Manual 01: Control Center and Data Exchange Requirements – Revision 44

Markets and Reliability Committee
April 27, 2022

Section 4.1.5: Member Communication Requirements

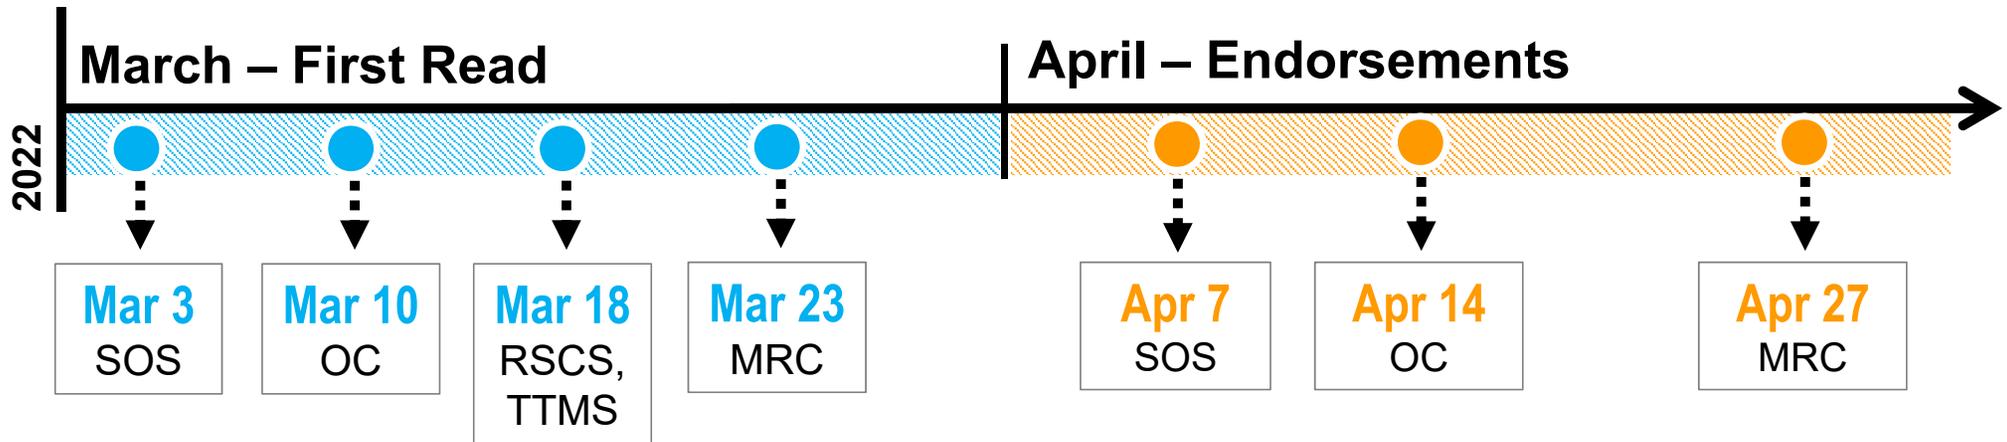
- Added additional entities with which Member communications are required, as it relates to COM-001.
 - Each Member shall have internal Interpersonal Communication capabilities for the exchange of information necessary for the Reliable Operation of the BES between the Member TO Control Center and field personnel, each Distribution Provider, Generator Operator, neighboring Member TOs internal to PJM, and neighboring TOs/TOPs external to PJM as applicable.
